To: T10 Technical Committee
From: Robert Sheffield (Robert.L.Sheffield@intel.com), Intel Corporation
Date: May 12, 2004
Subject: T10/04-030r3, SAS-1.1: Fix SP Hang States

Figure 68 — SP (phy layer) state machine - OOB sequence states

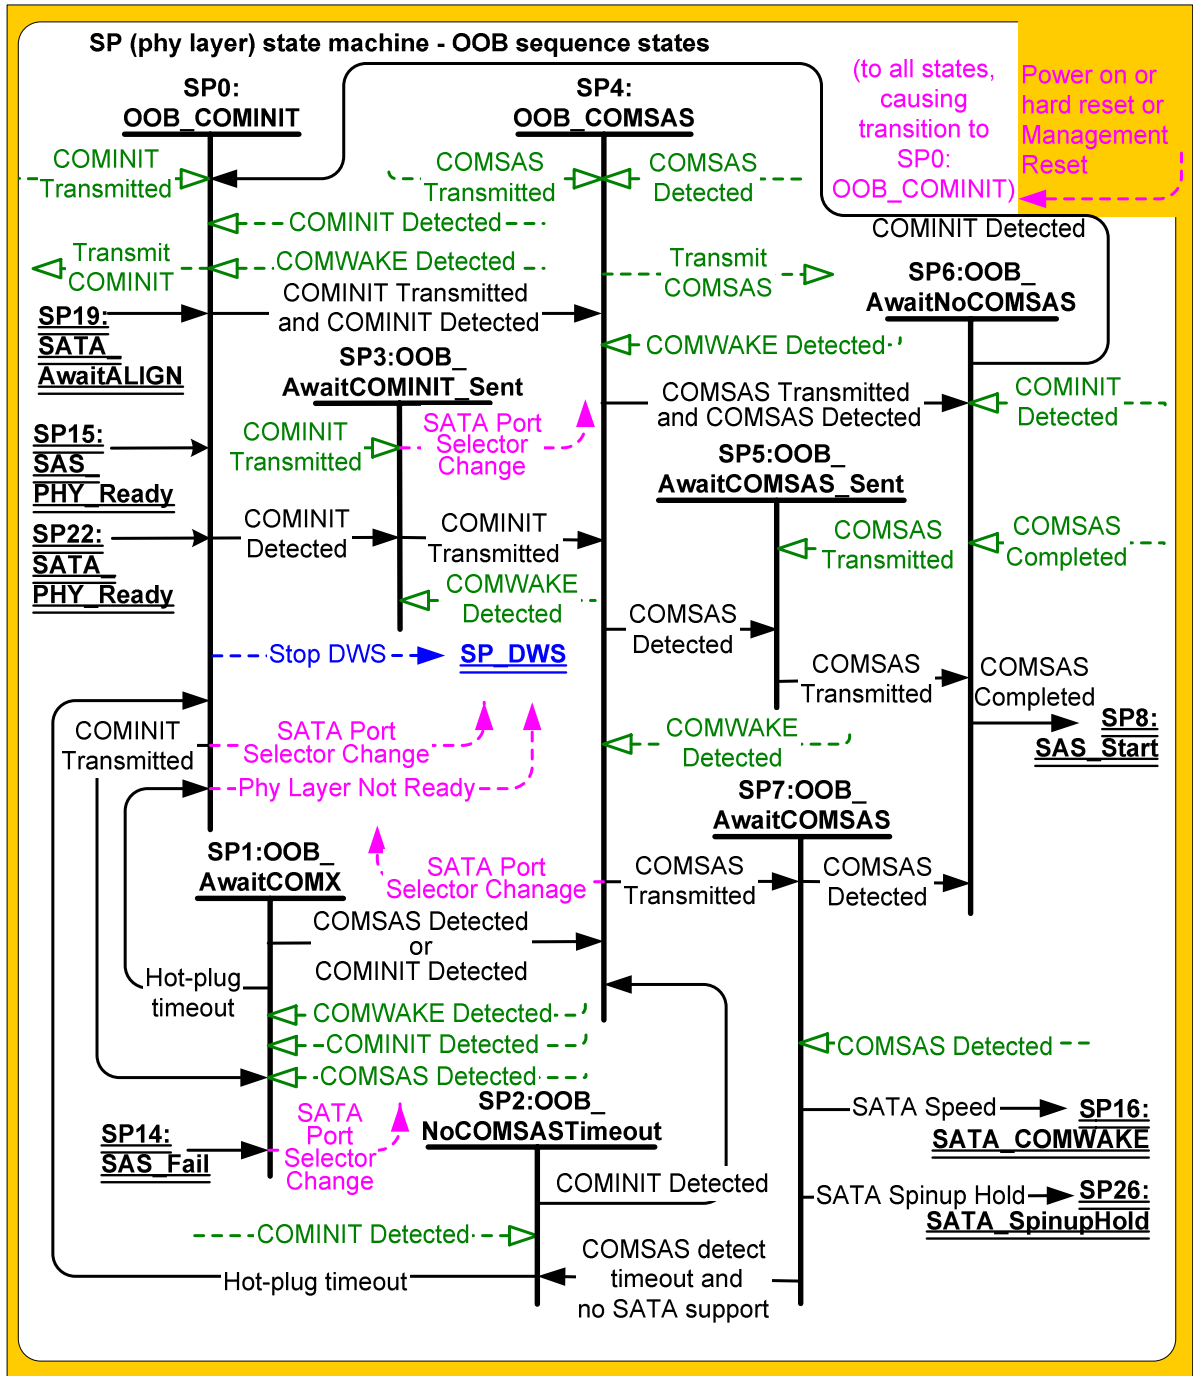
Replace figure 61 in section 6.7.3.1 OOB sequence states overview with the following figure:

6.7.3.8.3 Transition SP6:OOB_AwaitNoCOMSAS to SP0:OOB_COMINIT

This transition shall occur after receiving a COMINIT Detected message.

6.7.3.9.2 Transition SP7:OOB_AwaitCOMSAS to SP26:SATA_SpinupHold

This state shall send a SATA Spinup Hold confirmation to the link layer and this transition shall occur if,

- a) this phy is in an expander device;
- b) this phy supports attachment to a SATA device;
- c) the COMSAS Detect Timeout timer expires;
- d) this expander device implements SATA spinup hold; and
- e) the value of the MgmtReset machine state variable is zero.

This transition shall set MgmtReset to zero.

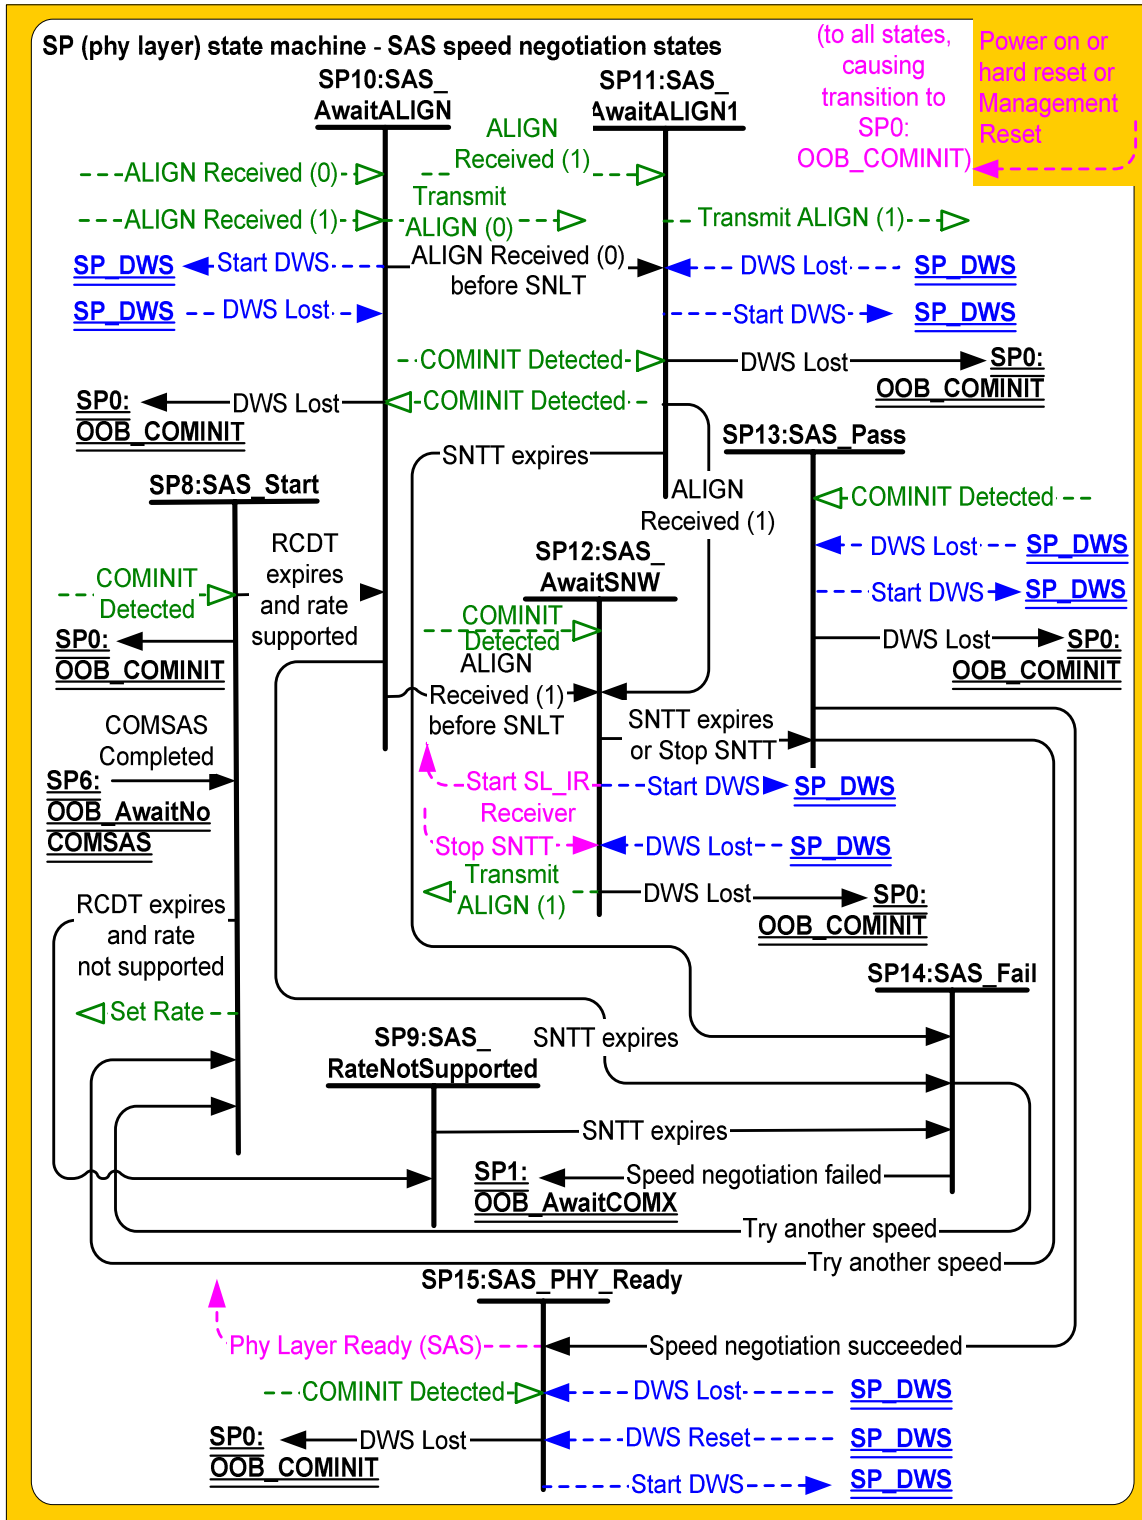
Replace figure 69 – SP (phy layer) state machine – speed negotiation states with the following figure:

6.7.4.2.4 Transition SP8:SAS_Start to SP0:OOB_COMINIT

This transition shall occur after receiving a COMINIT Detected message.

6.7.4.4.2 Transition SP10:SAS_AwaitALIGN to SP0:OOB_COMINIT

This transition shall occur after receiving a DWS Lost message if this state does not send a Start DWS message. This transition shall occur after receiving a COMINIT Detected message.

6.7.4.5.2 Transition SP11:SAS_AwaitALIGN1 to SP0:OOB_COMINIT

This transition shall occur after receiving a DWS Lost message if this state does not send a Start DWS message. This transition shall occur after receiving a COMINIT Detected message.

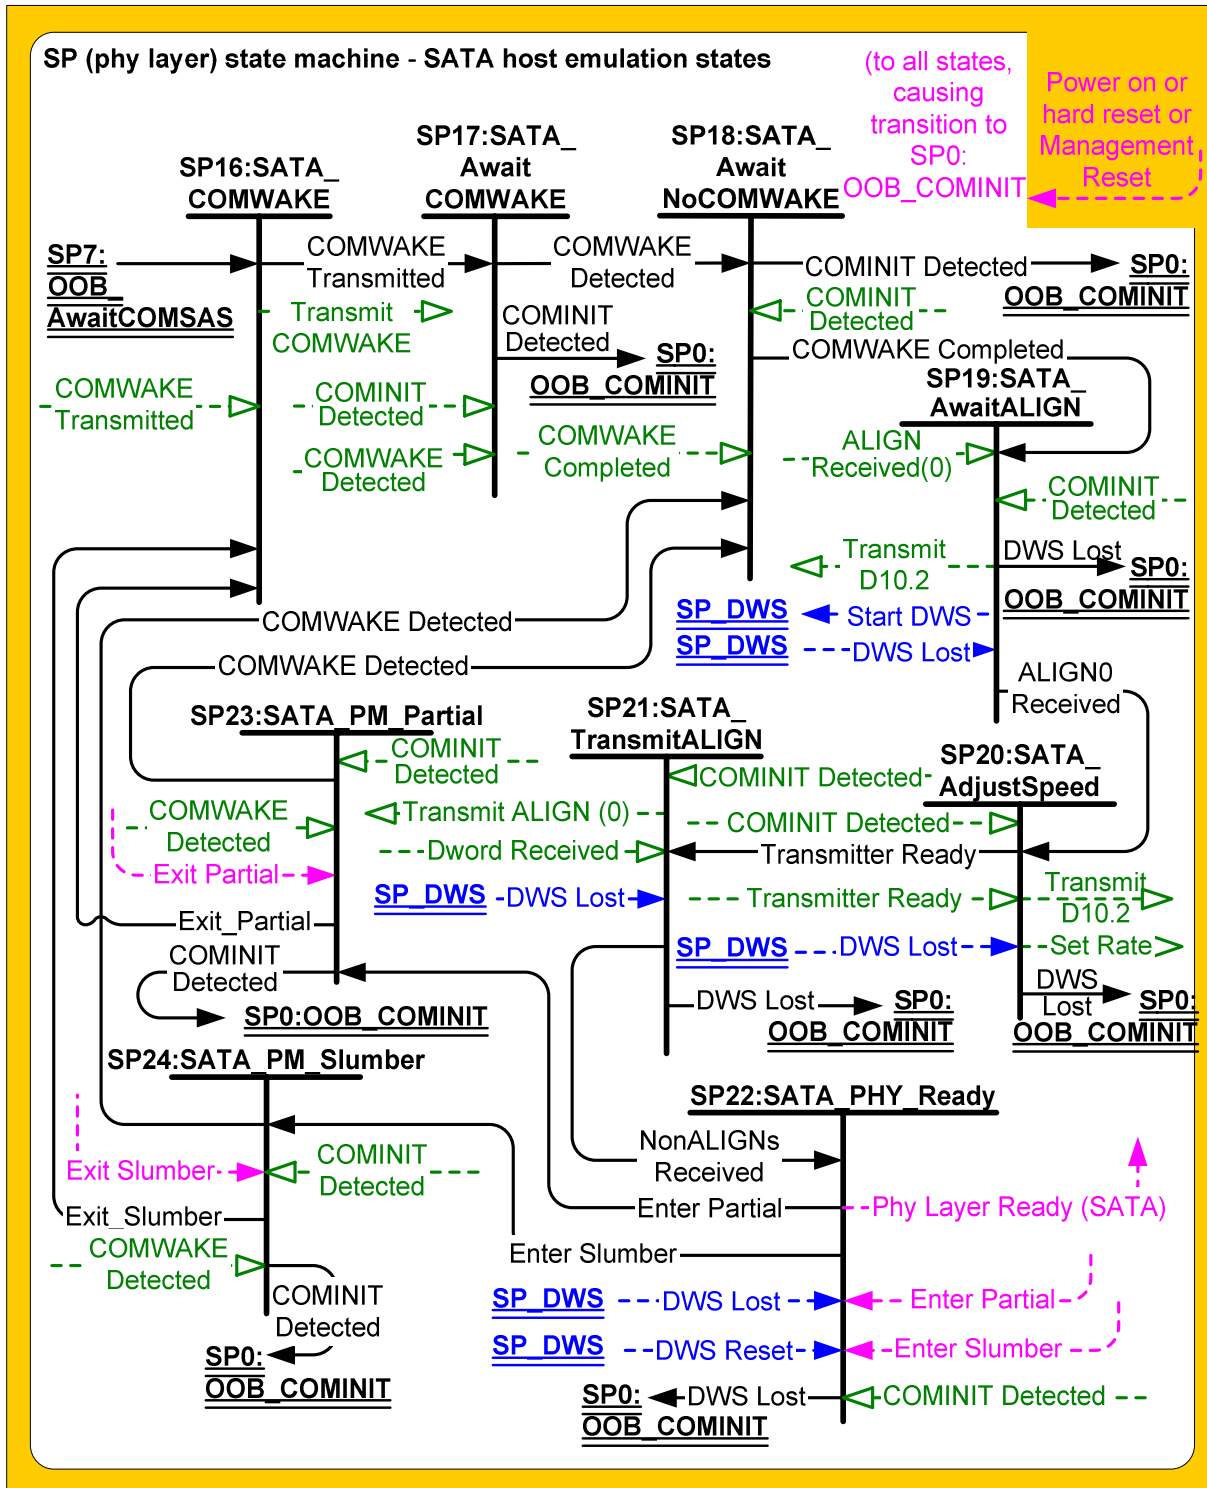
Replace figure 70 – SP (phy layer) state machine – SATA emulation states with the following figure:

6.7.5.3.3 Transition SP17:SATA_AwaitCOMWAKE to SP0:OOB_COMINIT

This transition shall occur after receiving a COMINIT Detected message.

6.7.5.4.3 Transition SP18:SATA_AwaitNoCOMWAKE to SP0:OOB_COMINIT

This transition shall occur after receiving a COMINIT Detected message.

6.7.5.9.4 Transition SP23:SATA_PM_Partial to SP0:OOB_COMINIT

This transition shall occur after receiving a COMINIT Detected message.

6.7.5.10.4 Transition SP23:SATA_PM_Slumber to SP0:OOB_COMINIT

This transition shall occur after receiving a COMINIT Detected message.

Figure 72 — SP (phy layer) state machine – SATA Spinup Hold State

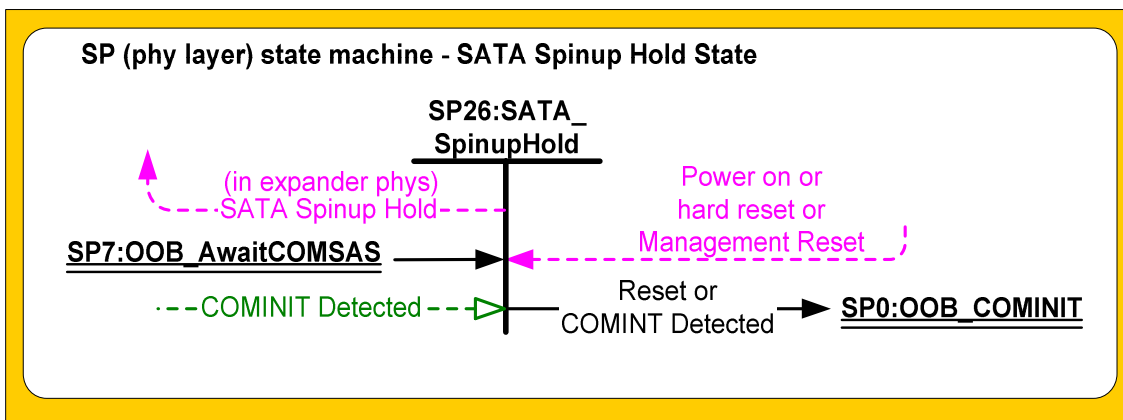
Figure 72 shows the SP26:SATA_SpinupHold state. This state shall be entered from the SP7:OOB_AwaitComsas state upon detection of a COMSAS detect timeout if the phy supports SATA, the phy supports Spinup Hold, and the MgmtReset state machine variable has a value of zero.

6.7.7.2 Transition SP26:SATA_SpinupHold to SP0:OOB_COMINIT

This transition shall occur if this state receives a COMINIT Detected message, a Management Reset request from the management layer, a hard reset, or a power on. If this transition is caused by a Management Reset Request from the management layer, it shall cause MgmtReset to be set to one upon entry to SP0:OOB_COMINIT. Otherwise, MgmtReset shall be set to zero upon entry to SP0:OOB_COMINIT.
